FOXCONN A75M02

FAB: 1.0

AMD FM1 APU + FCH HUDSON D2/D3 CHIPSET

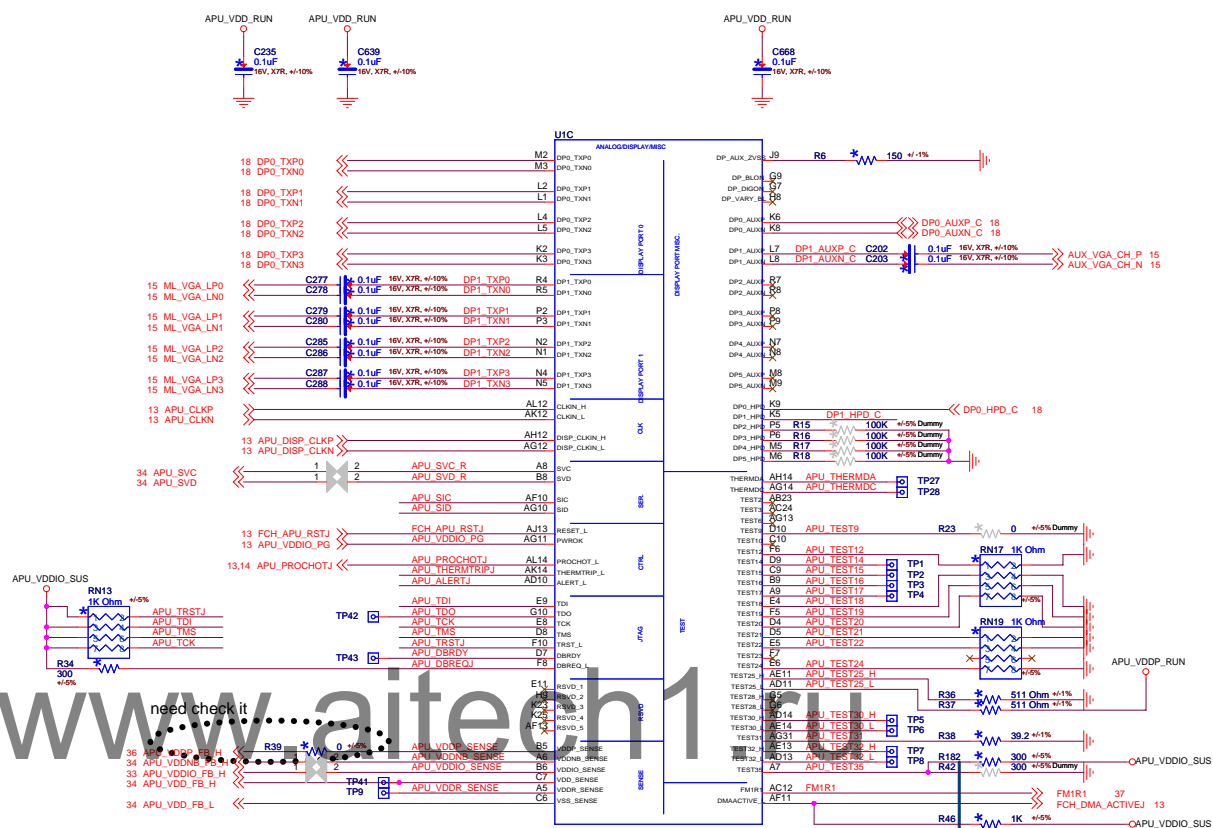
2011-07-07: For ISL6328_POWOK_R Dummy R187, Q7, R207, stuff R43 following CRB

2011-07-07: Change R182 from 1k to 300 ohm

HDMI CONNECTOR

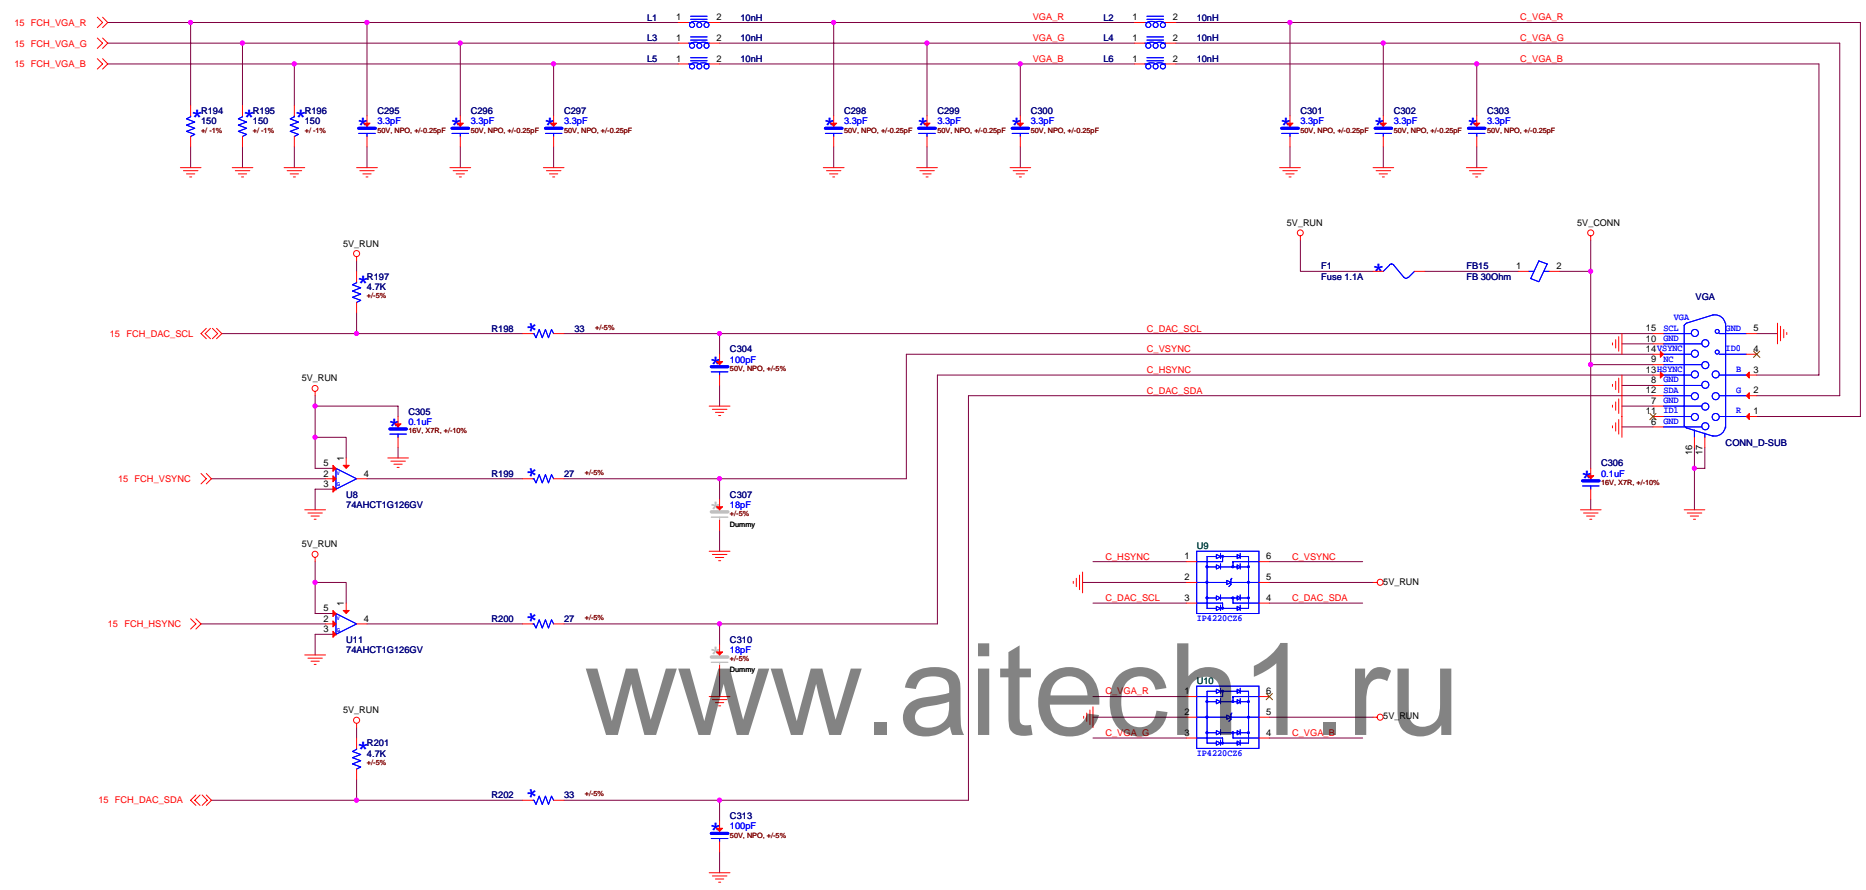
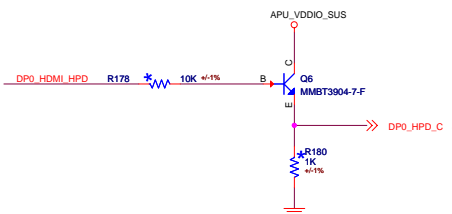
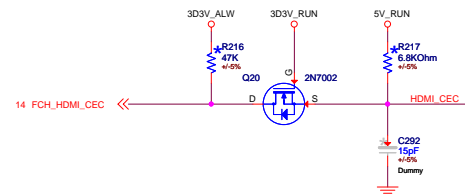
Q11,Q14 需要重新调料

2011-09-01: For fix HDMI can't display issue
1, Change RN21 RESA from 1Kohm to R508,R509(4.7Kohm), R518,R519(0ohm)
2, Change Q11,Q14 from 3904 to PMV16UN

FUSB2 (Data 8 & 9)

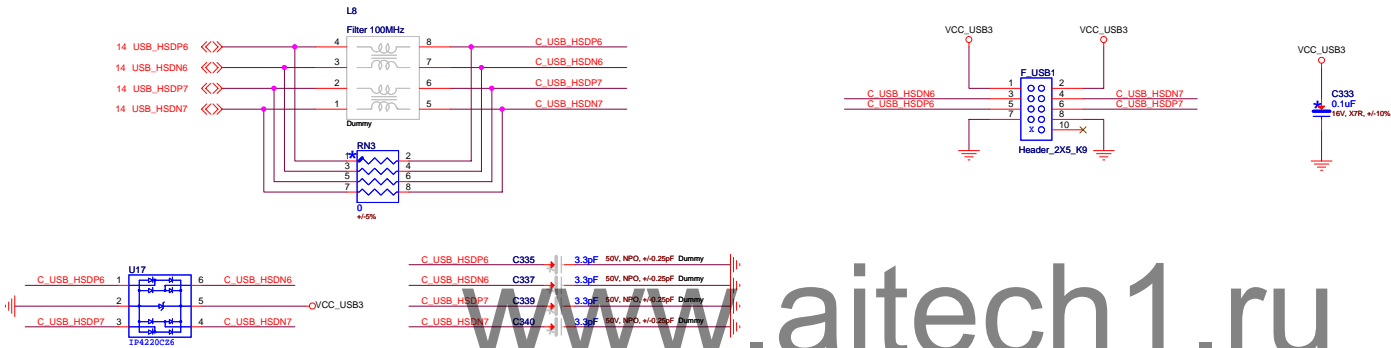
2011-07-27: Delete U18

REAR USB3.0 (USB3.0 data 0 & 1 / USB2.0 data 10 & 11)

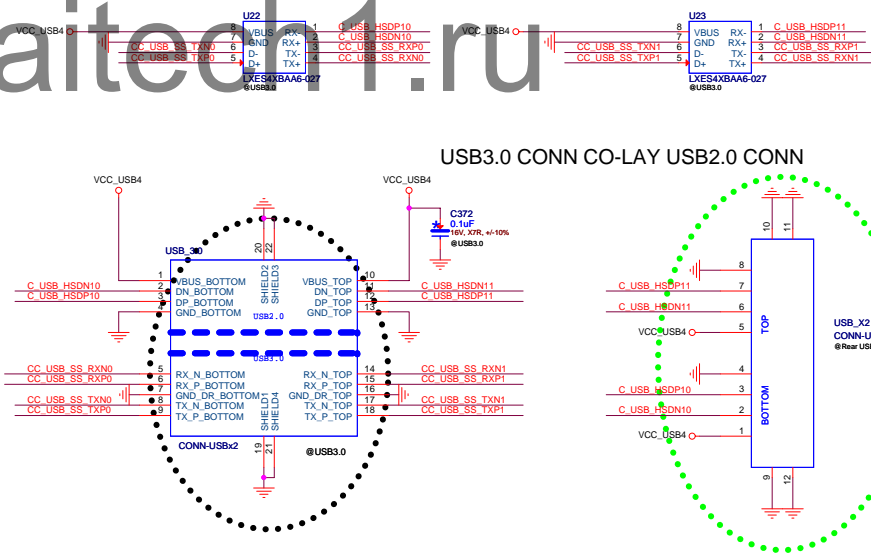
2011-08-31: Change USB3.0 CONN from 34041R400-600-G to 34041QY00-600-G(shorter)

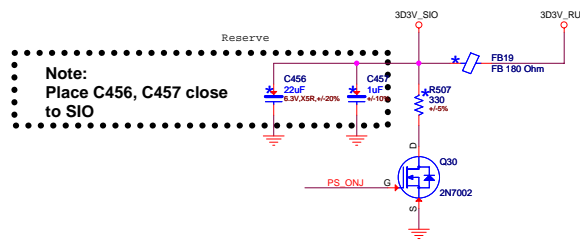
2011-08-20: exchange SYSFAN_TAC and SYSFAN_CTL

2011-08-11: Change FB10 from FB to GAP for match ITE request

PWR MAIN & OTHER POWERS

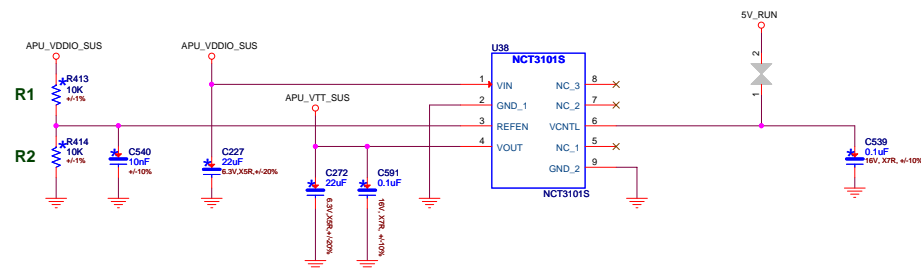
2011-08-11: Change EC19,EC35 from 16V 270uf to 6.3V 470uf to slove Pin too close to board edge

1D1V_RUN

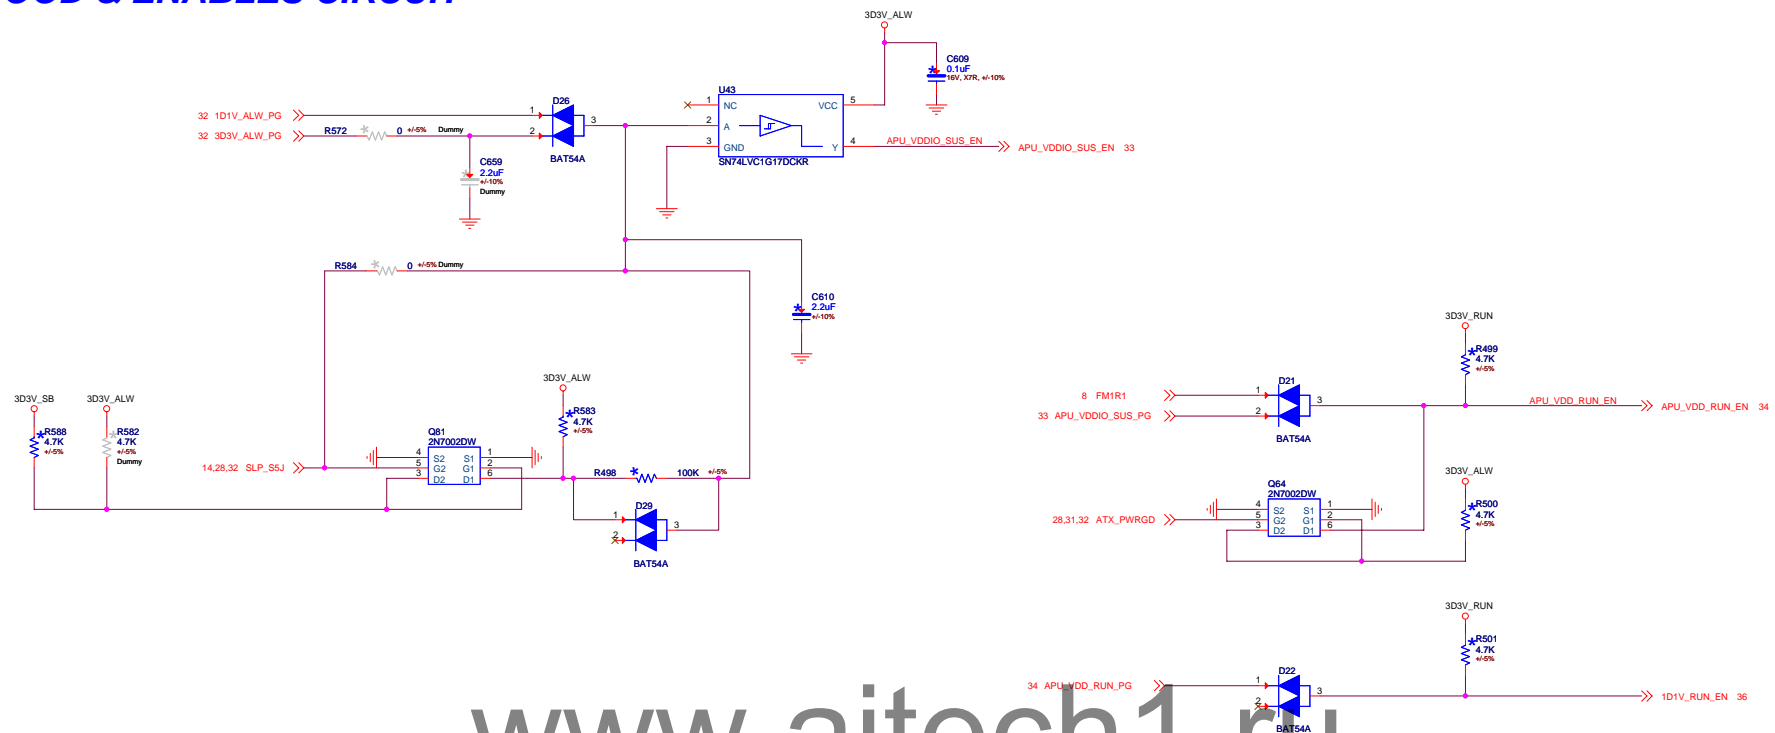
**2011-06-21: For 1D1V_RUN
power sequence request
1, Change R497 from 1K to 10K**
